# A12 Chelmsford to A120 DCO Review

## Alternative De-trunking Proposals

### Technical Note

<b>Report Title</b>	A12 Chelmsford to A120 DCO Review: Alternative De-trunking Proposals Technical Note
<b>Project Number</b>	B3553RB1
<b>Status</b>	Final
<b>Revision</b>	V1
<b>Control Date</b>	March 2023

Figure 24 – A parallel crossing with increased stacking space on the northern arm of the London Road Roundabout, possible by reducing its ICD

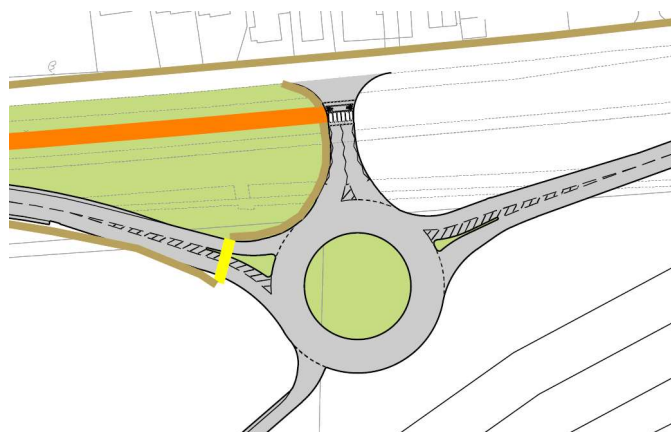
NH has tested the performance of Junction 25 using VISSIM microsimulation software. For this review, Essex Highways has used ARCADY to model the London Road roundabout separately in order to test its performance when reducing the existing A12 to a single lane carriageway. Traffic flows have been ascertained from NH' VISSIM matrices but with added reasonable assumptions on turning movements, specifically on London Road, in order to obtain a matrix for the roundabout. These matrices are shown in Appendix E - Matrices Used for London Road Roundabout ARCADY Modelling.

Using the above results, EH has provisionally proposed a 50m ICD (a reduction of around 10m from NH’ proposal) for the London Road Roundabout. This reduction in size will result in cost reductions associated with construction of the junction in terms of both material and labour which can be reinvested to help finance the wider scheme. In addition, there is increased space north of the junction to extend the distance between the roundabout’s circulatory and the junction with Old London Road. With this additional space available for vehicle stacking, it is now possible to provide a parallel crossing across this northern arm with a reduced likelihood of vehicles waiting at the crossing queuing back onto the roundabout’s circulatory, as shown in Figure 24.

Figure 25 – Indicative design for an all-movements junction onto the western end of Old London Road.

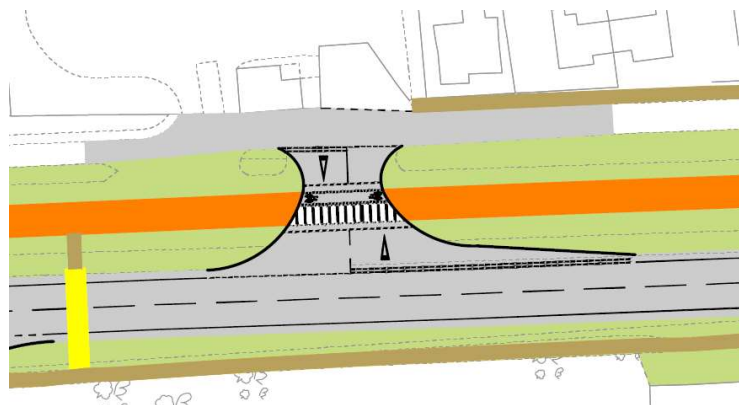
Stakeholders highlighted that currently, commercial vehicles leaving an industrial site off Old London Road are required to travel along Old London Road, as there is no direct access on the westbound carriageway of the A12. Being that Old London Road is a residential road the removal of this traffic would be beneficial to residents.

EH has further considered the issue in the context of a single carriageway arrangement. The initial design indicates that it should be possible to enable right-in/out where the existing eastbound access onto Old London Road is positioned. In facilitating all movements commercial traffic would not be required to utilise Old London Road. An initial design for this junction arrangement can be seen in Figure 25.
